COMPLETE STREETS COMMISSION SPECIAL MEETING AGENDA

6:00 PM - Wednesday, May 21, 2025

- [1.](#) FY24-25 Annual Street Resurfacing Project

2024-2025 ANNUAL STREET RESURFACING PROJECT

S. EL MONTE AVENUE
FROM CUESTA DRIVE TO CLARK AVENUE
SCALE: 1" = 20'

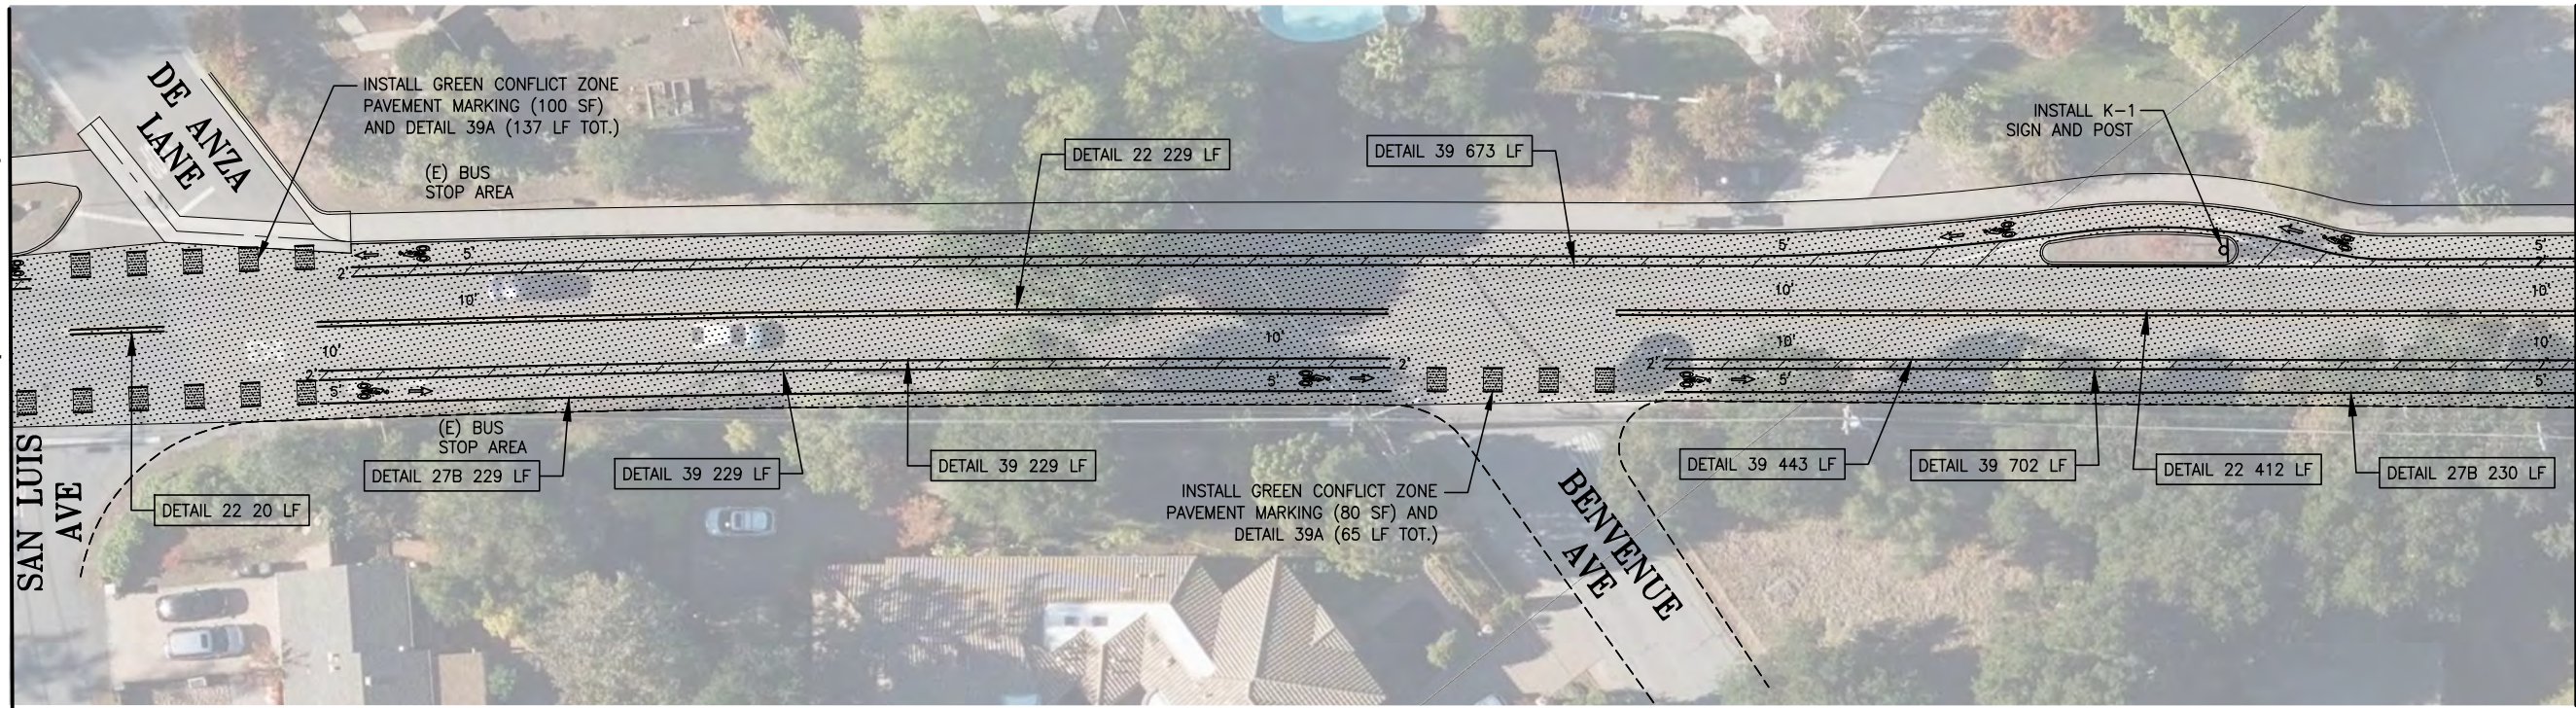
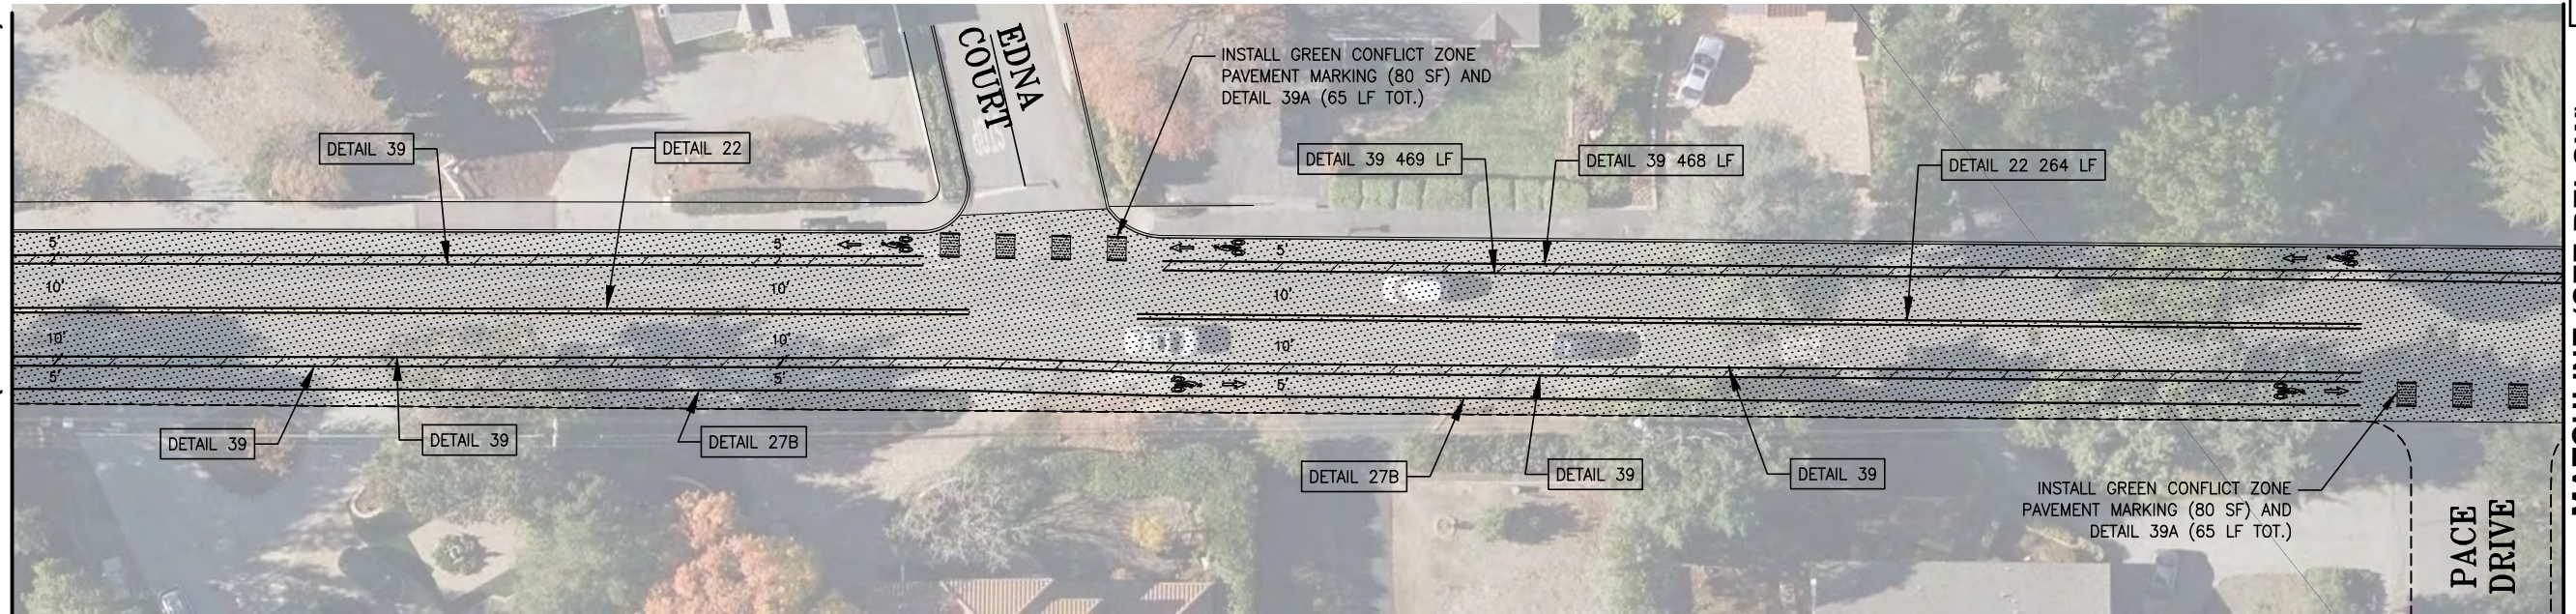
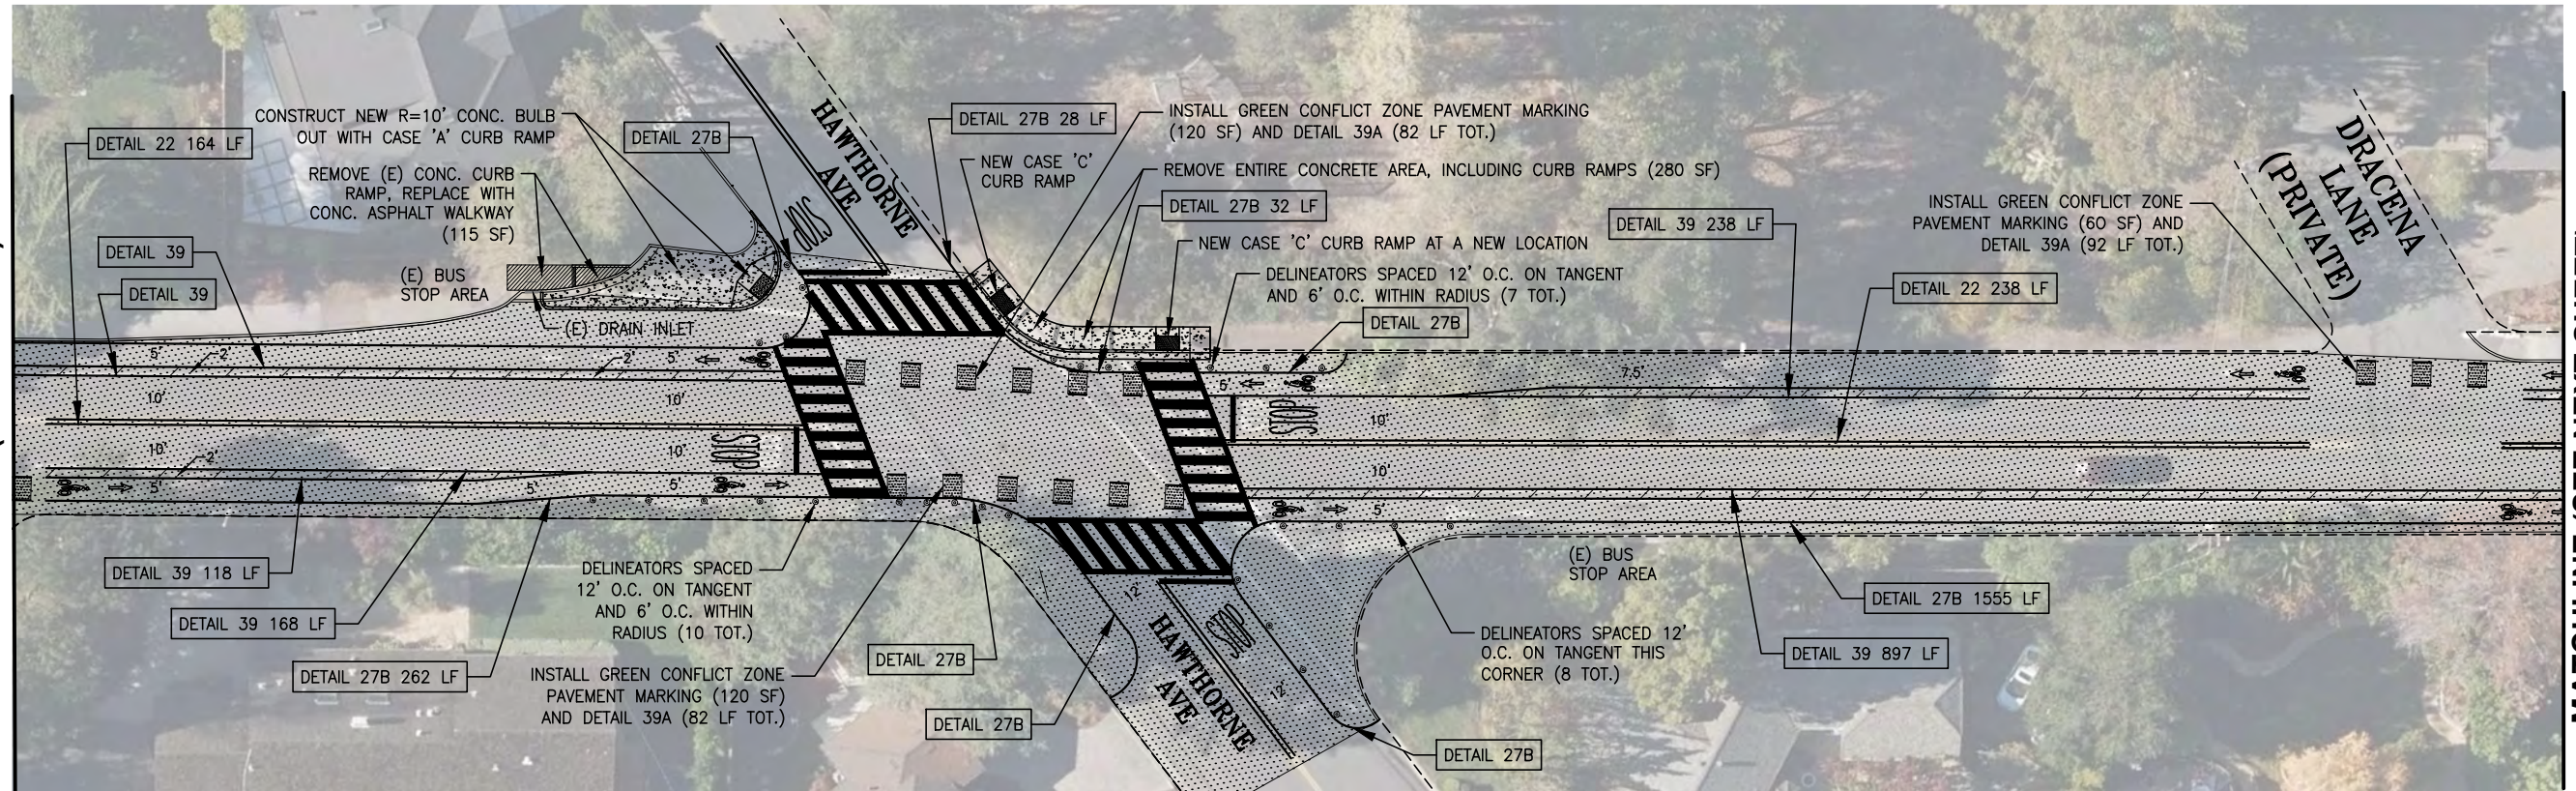
On your discussion about the intersection of El Monte and S. Clark Ave, you are proposing a delineator barrier on S. Clark, on the east side of the street, just before S. Clark meets El Monte. I am concerned that this barrier will reduce the space allowed for bicyclists on the street going north on S. Clark. The description in the meeting showed that the delineator was a continuous raised barrier (about 4-6 inches) and then vertical posts about every 8-10 feet. From that description, bikes can't ride over that, so they will be forced to share the single lane with cars. A lot of school-aged children bike to school on S. Clark, so in my view, this whole set-up there is confusing and potentially dangerous for them. I think it would make a lot more sense to have some striping (no raised barrier) to designate a bike lane, so the kids know where to ride and give them a dedicated space to ride their bikes away from cars.
